Assemblies Affected: PA635

Symptom: PA635 Amplifier is not able to be controlled by IR under Code Group setting B0 as stated in the Manual.

Fig. 1: RC68+ Programmer Settings

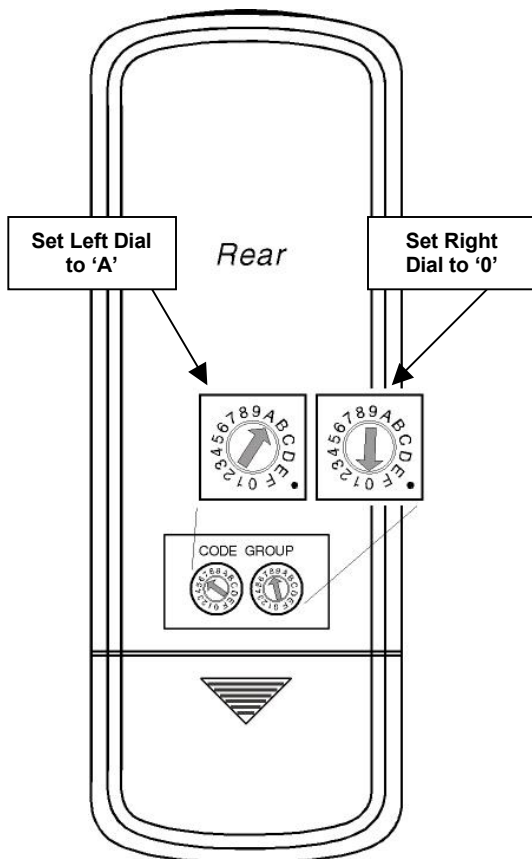
Cause: All PA635's are shipped with Default Code Group A0.

Set Dials on the rear of the RC68+ to A0 to control or if programming a Xantech IR Component with Dragon Drop-IR™ Software, do the following: (See Figures below).
